TECHNICAL MEMORANDUM

Project No. 20446521-003-TM-Rev0-6000

DOMES DESIGN ISSUED FOR CONSTRUCTION DRAWINGS

PROJECT
WASTE ROCK DOME DESIGN
LUPIN MINE CLOSURE
NUNAVUT, CANADA

TITLE
PROPOSED WASTE ROCK DOME SECTIONS AND DETAILS

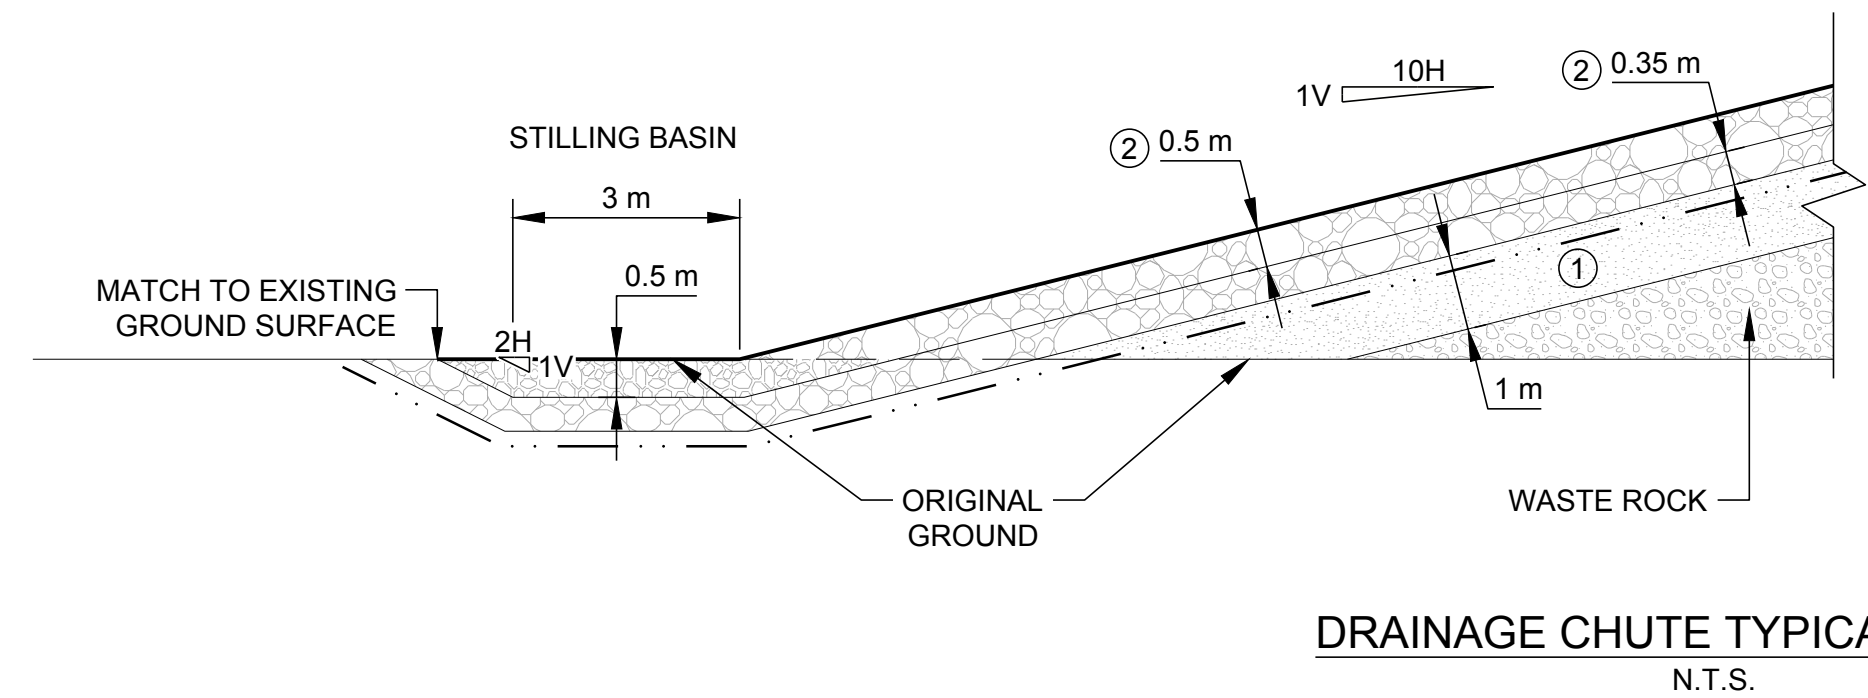
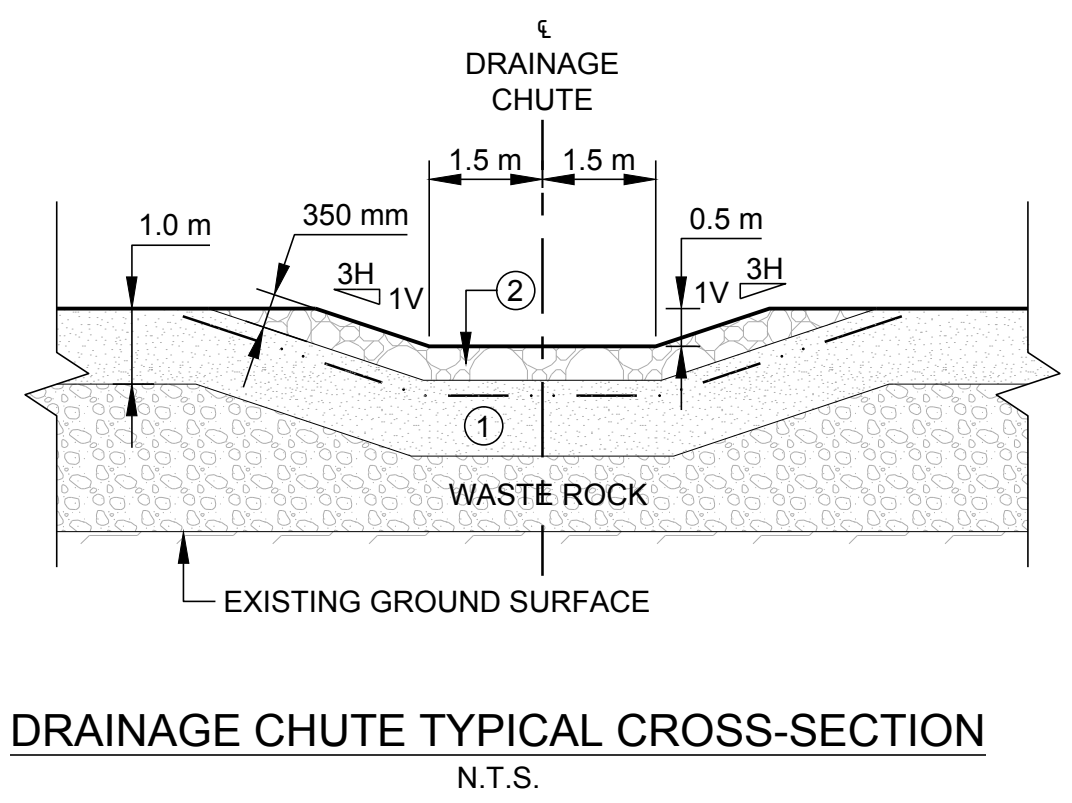
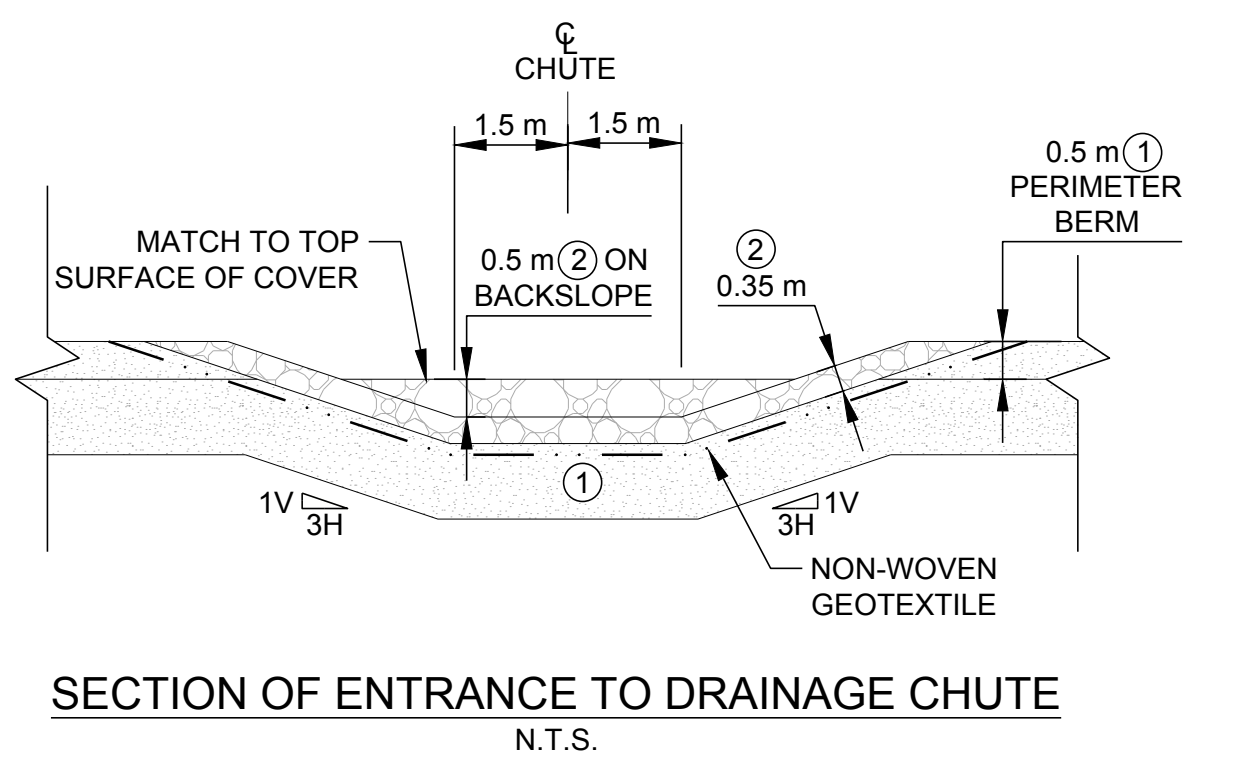
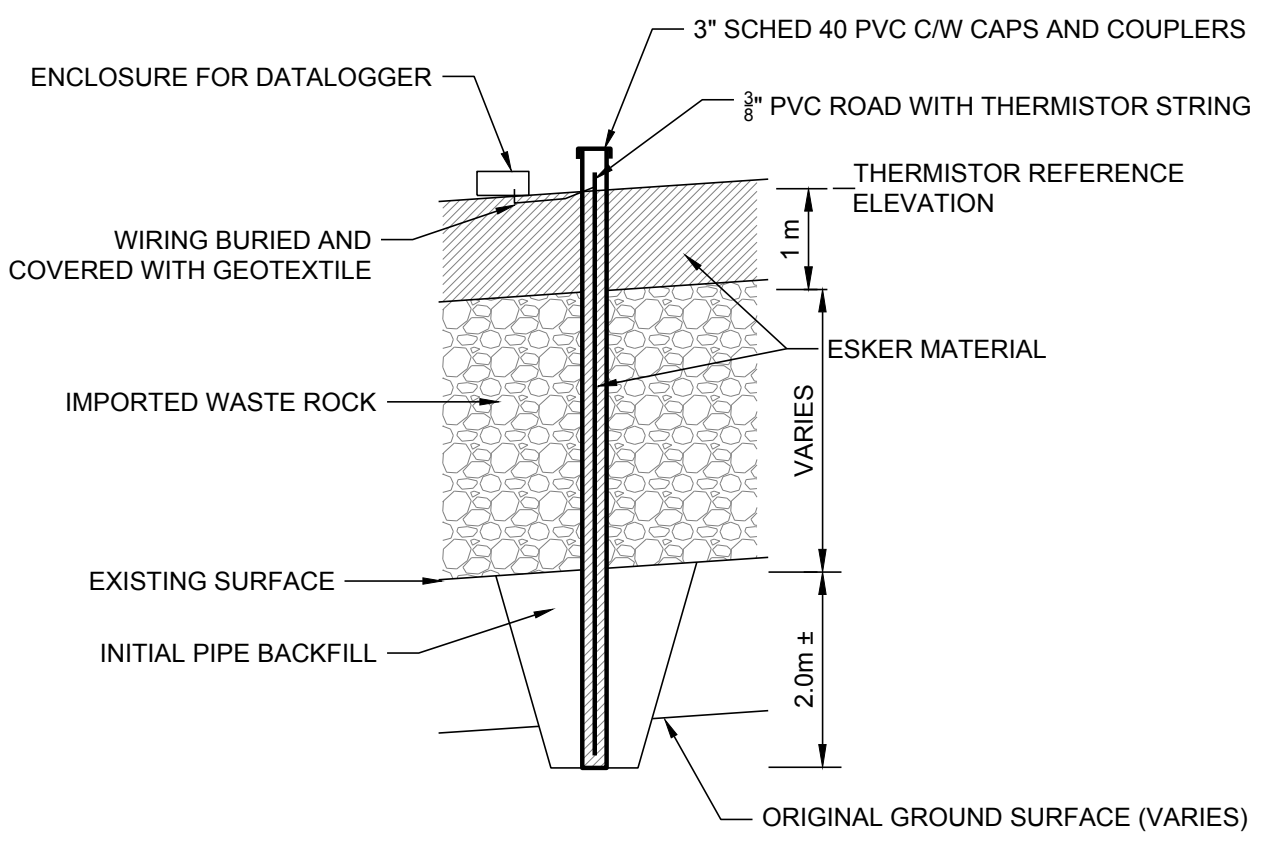
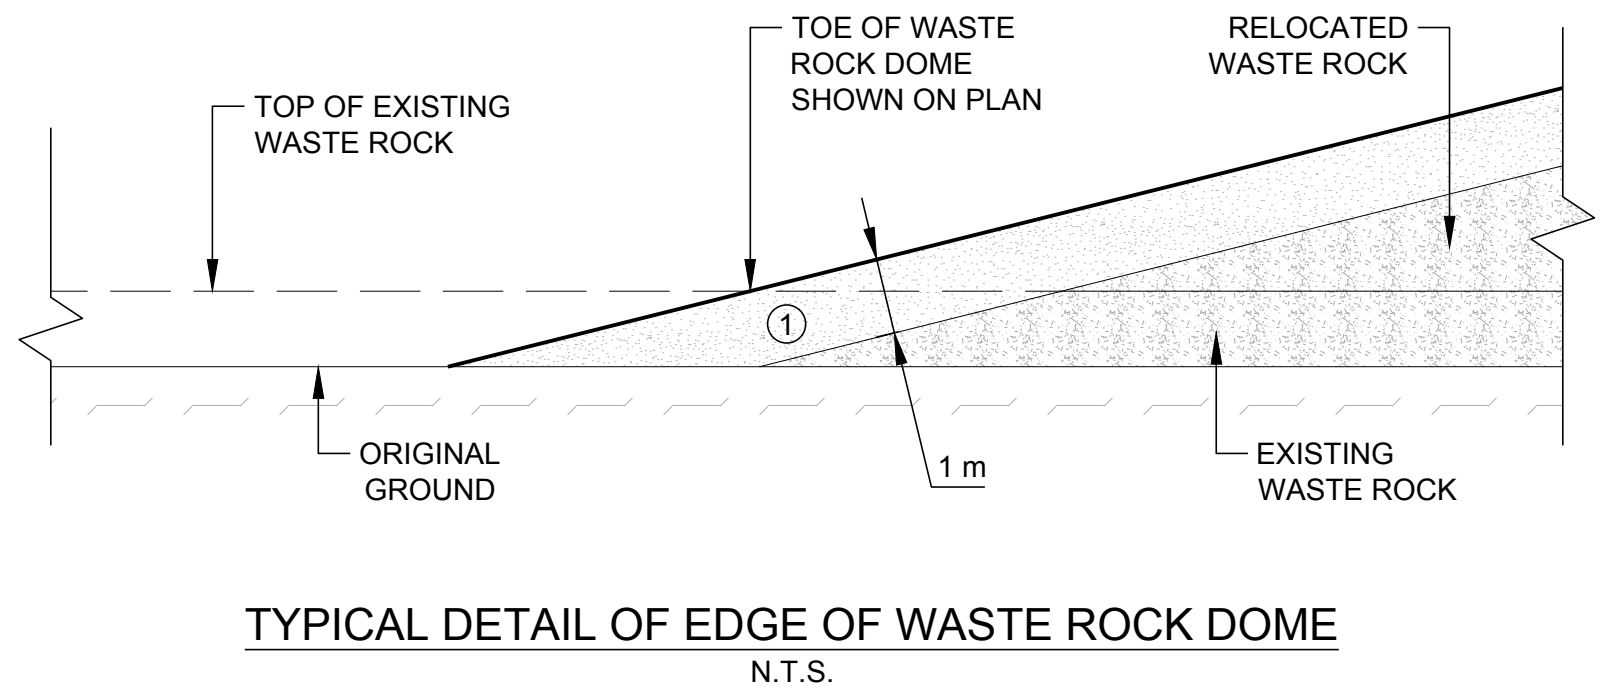
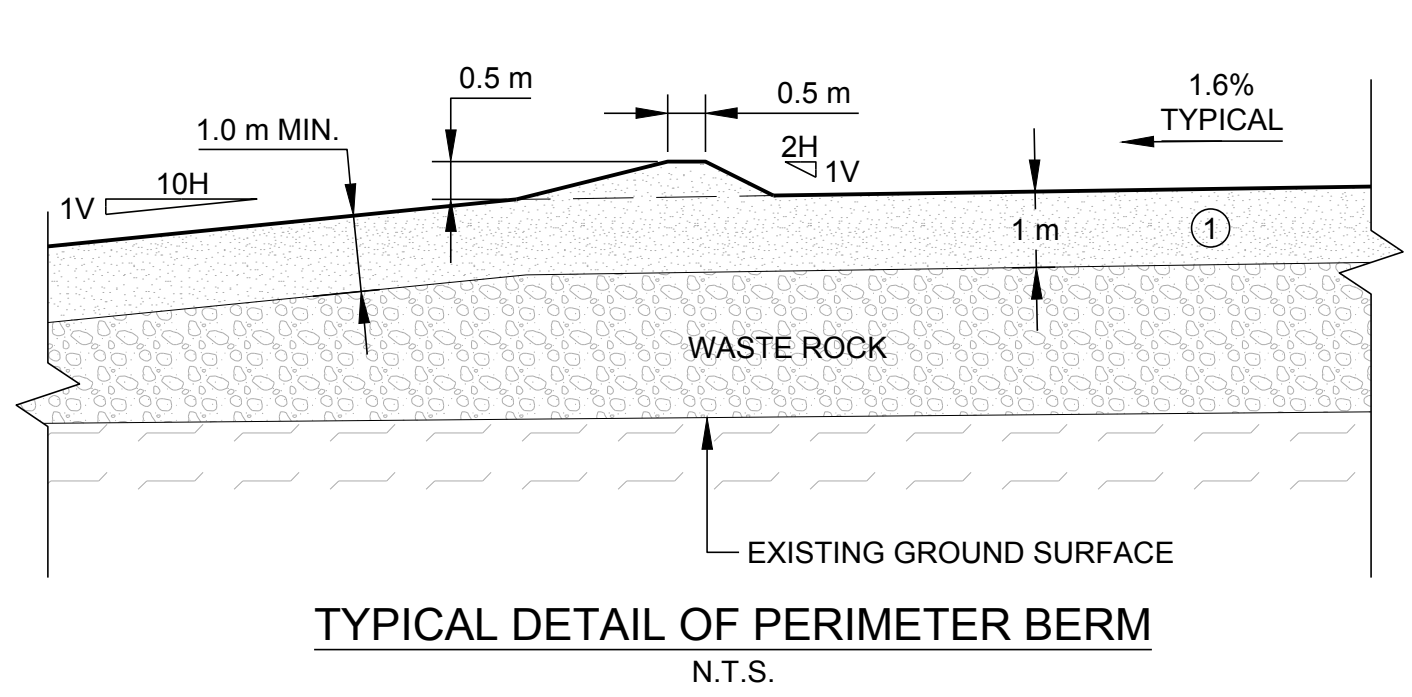
In reviewing the typical drainage chute details, it appears to us that they are inconsistent as the 0.5 m depth of the drainage chute as shown in cross section is shown as 0.5 m berm on the top of the chute drainage profile detail and the perimeter berm is not shown on this detail. A plan view detail of the top and bottom of the drainage chutes should be provided.

This has been clarified on Dwg. 19136158-0002-CM-0002_Rev 1, which also includes a section detailing the erosion protection at the entrance to each chute.

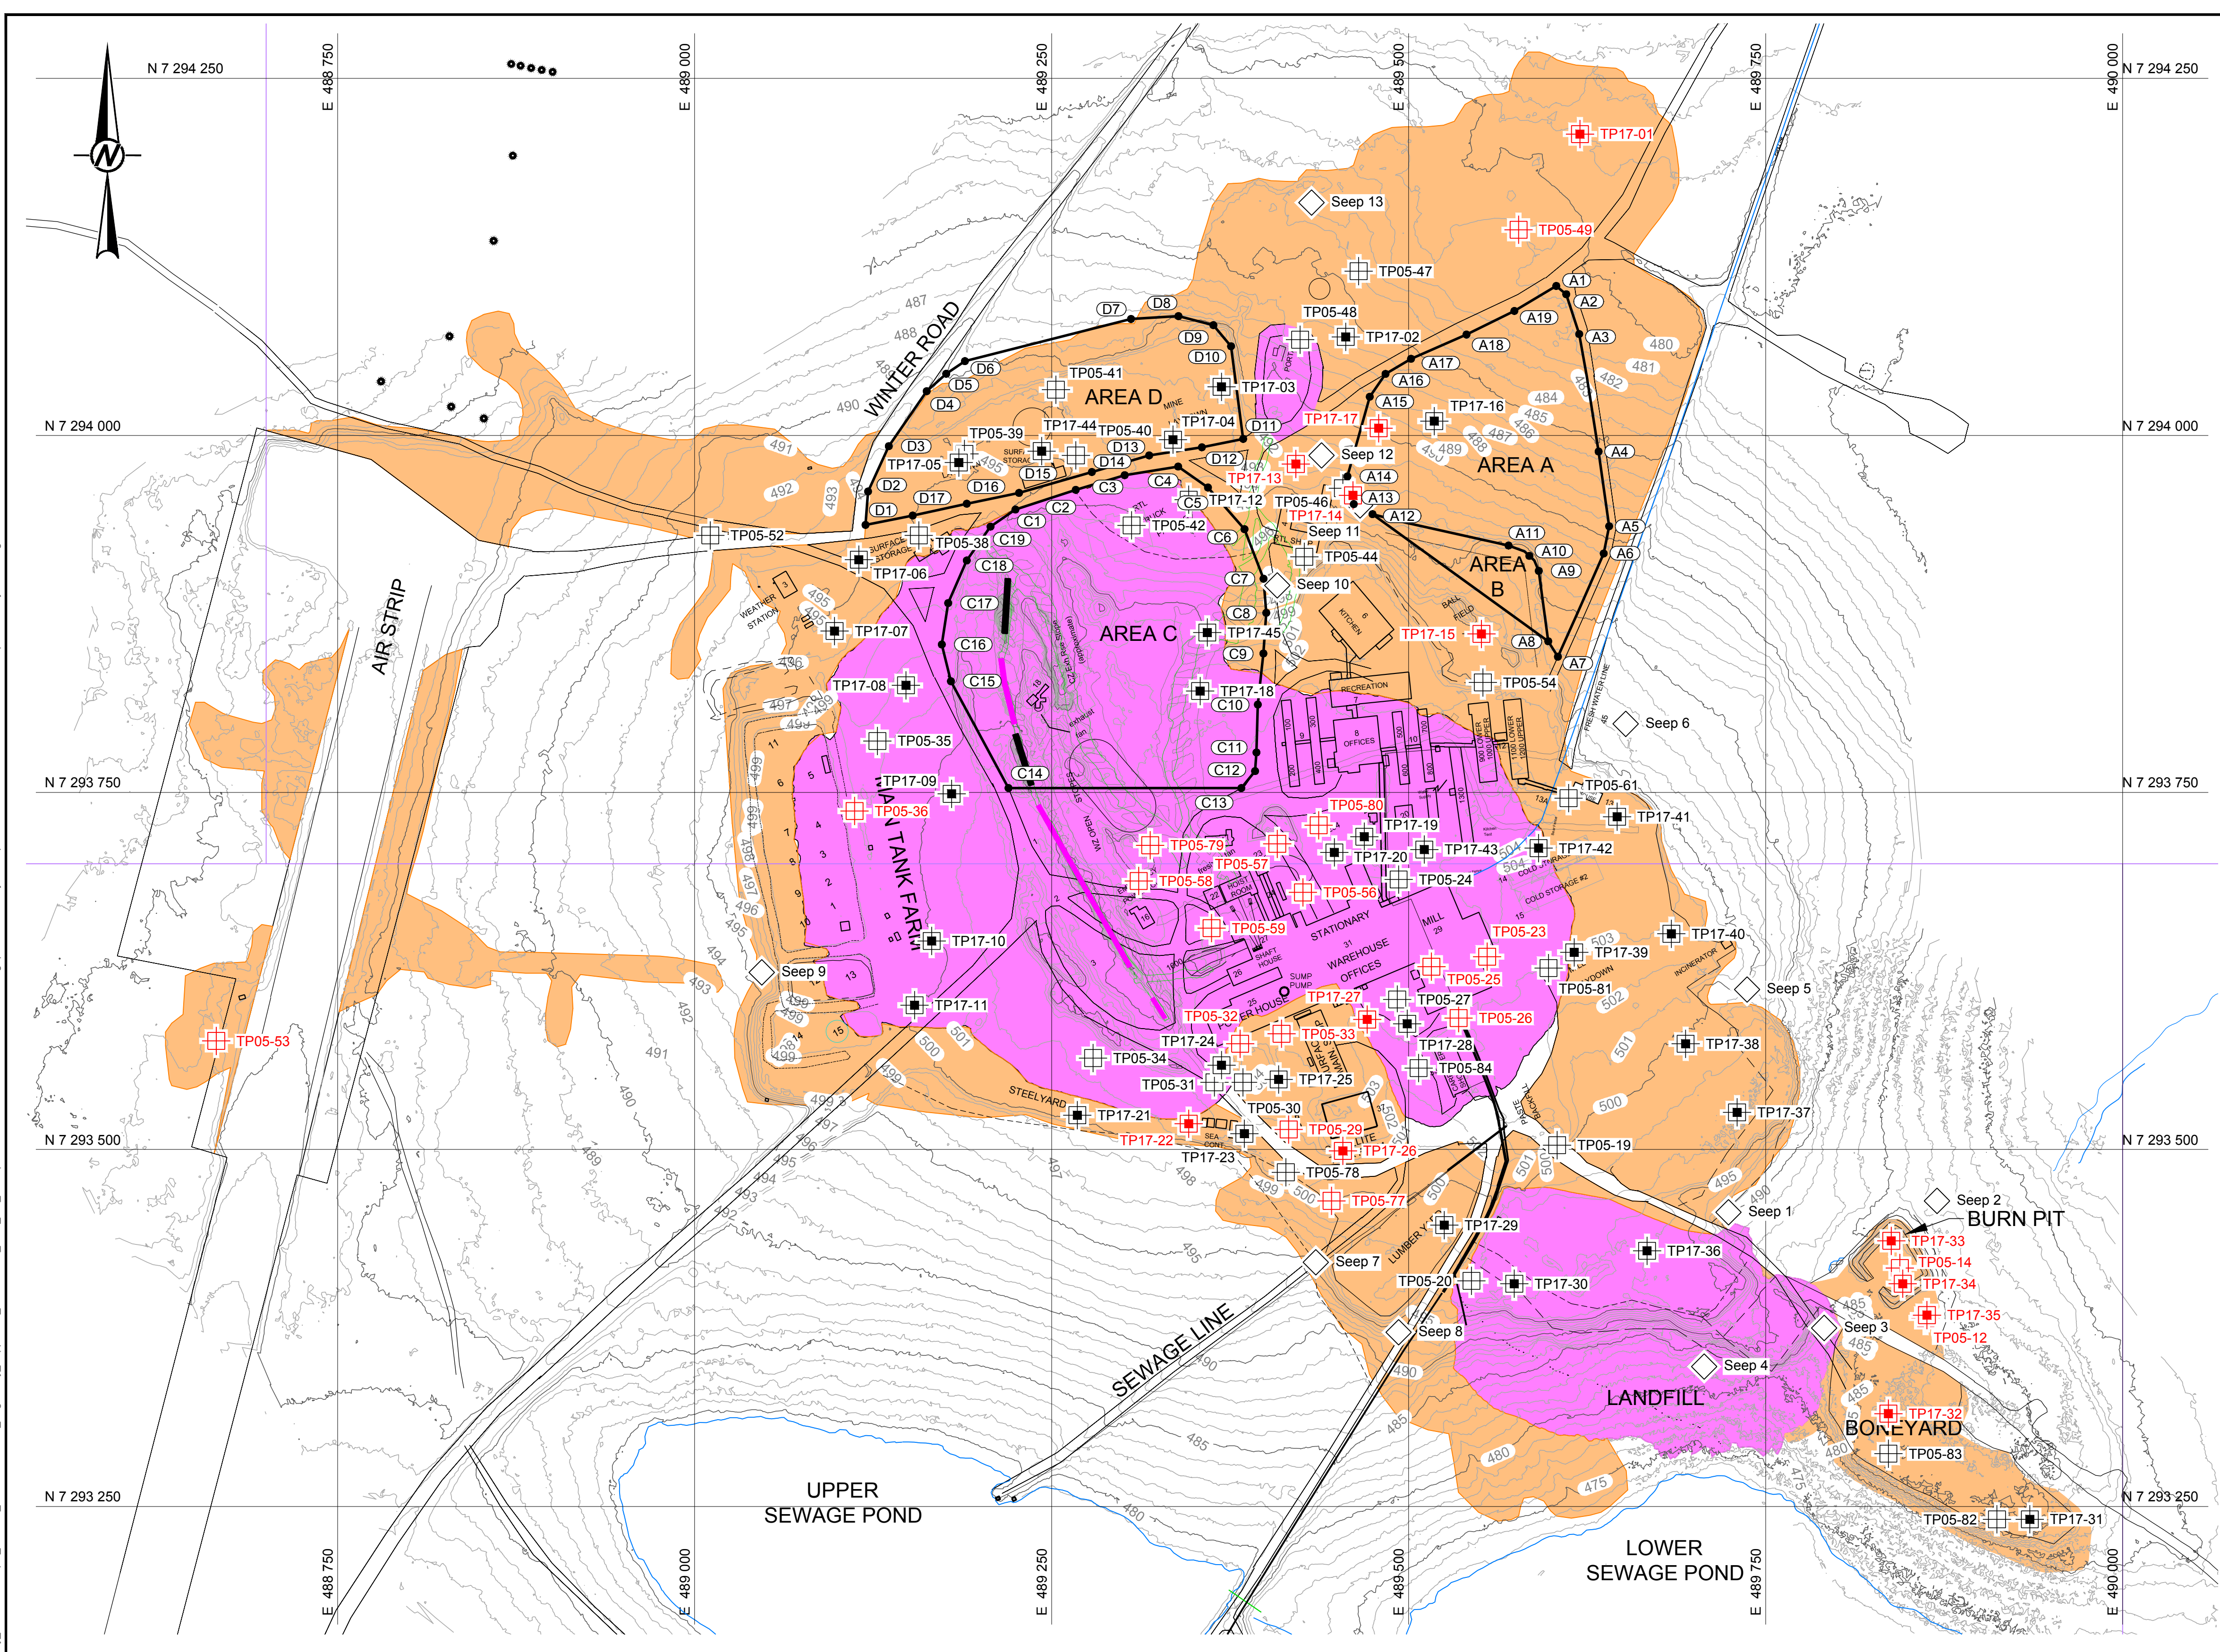
g. failure to show where materials to be removed prior to cover placement are located; and

- Drawing Note 2 provides a list of materials that are to be removed before waste rock is placed, but the drawing does not identify the locations of these materials. It is unclear how this will be achieved in the absence of specific references to the dome plan. Include location of materials to be removed before waste rock placement.

Moreover, in addition to our specific concerns with the "dome" design concepts, we are also generally concerned that the remedial requirements that need to be undertaken are not specifically identified or referenced on the plan provided. We are concerned for example that in the absence of specific information on where contaminated soils to be removed are located, that confirmation that these soils have been removed may not be considered prior to reworking of the waste rock and placement of the esker cover. Provide specific cross reference to these works to ensure that they are identified in the FCRP and noted as appropriate.

The areas where known soil contamination is present are shown on a separate drawing: Dwg. 19136158-0005-CM-0001 Rev. D.

As discussed above, the areas where known soil contamination is present are shown on a separate drawing: Dwg. 19136158-0005-CM-0001 Rev. D.

A copy of Dwg. 19136158-0005-CM-0001 Rev. D is attached. This shows the locations of all test pits where exceedances were identified in the two environmental site assessments (Morrow, 2006 and Golder, 2017). A copy of the August 2020 QA/QC Plan was provided to CIRNAC with LMI's technical responses to the updated FCRP on March 19, 2021. CIRNAC provided comments on the August 2020 QA/QC Plan to the NWB on April 8, 2021, and LMI responded to CIRNAC's comments on June 15, 2021. Furthermore, the QA/QC Plan (Lupin Mines Incorporated, 2021) was attached as Appendix C to the draft PCMP, which was submitted on April 8, 2021.
